Information processing — Data interchange on 12,7 mm (0.5 in) wide magnetic tape cartridges — 18 tracks, 1 491 data bytes per millimetre (37 871 data bytes per inch)

TECHNICAL CORRIGENDUM 2

Technical corrigendum 2 to International Standard ISO 9661 : 1988 was prepared by Joint Technical Committee ISO/IEC JTC 1, Information technology.

Figure 22

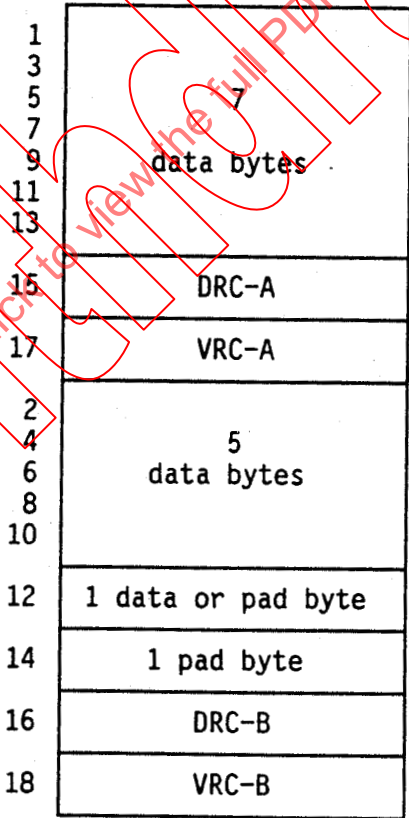
Replace the figure with the following:

"4.3.3.3 Residual Frame 1

If after the last Data Frame of the last Data cluster 12 or 13 data bytes remain to be recorded, there shall be a Residual Frame 1. If the number of remaining data bytes is less than 12 there shall be no Residual Frame 1.

The structure of the Residual Frame 1 shall be

- 12 or 13 data bytes;
- 1 or 2 pad bytes, depending on the number of remaining data bytes;
- in tracks 15 and 17 the DRC-A and the VRC-A, respectively;
- in tracks 16 and 18 the DRC-B and the VRC-B, respectively."

Figure 23

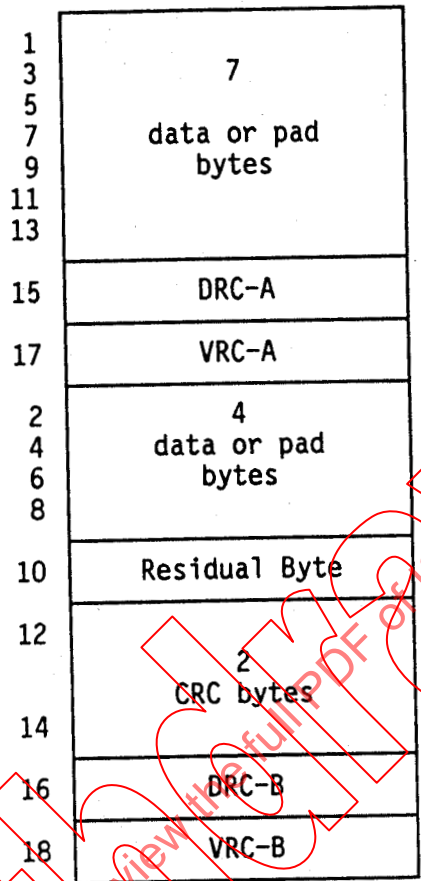
Replace the figure with the following:

"If there is no Residual Frame 1, i.e. if there are eleven or less remaining data bytes, these data bytes followed by sufficient pad bytes to total 11 bytes shall be recorded in odd tracks 1 to 13 and even tracks 2 to 8."
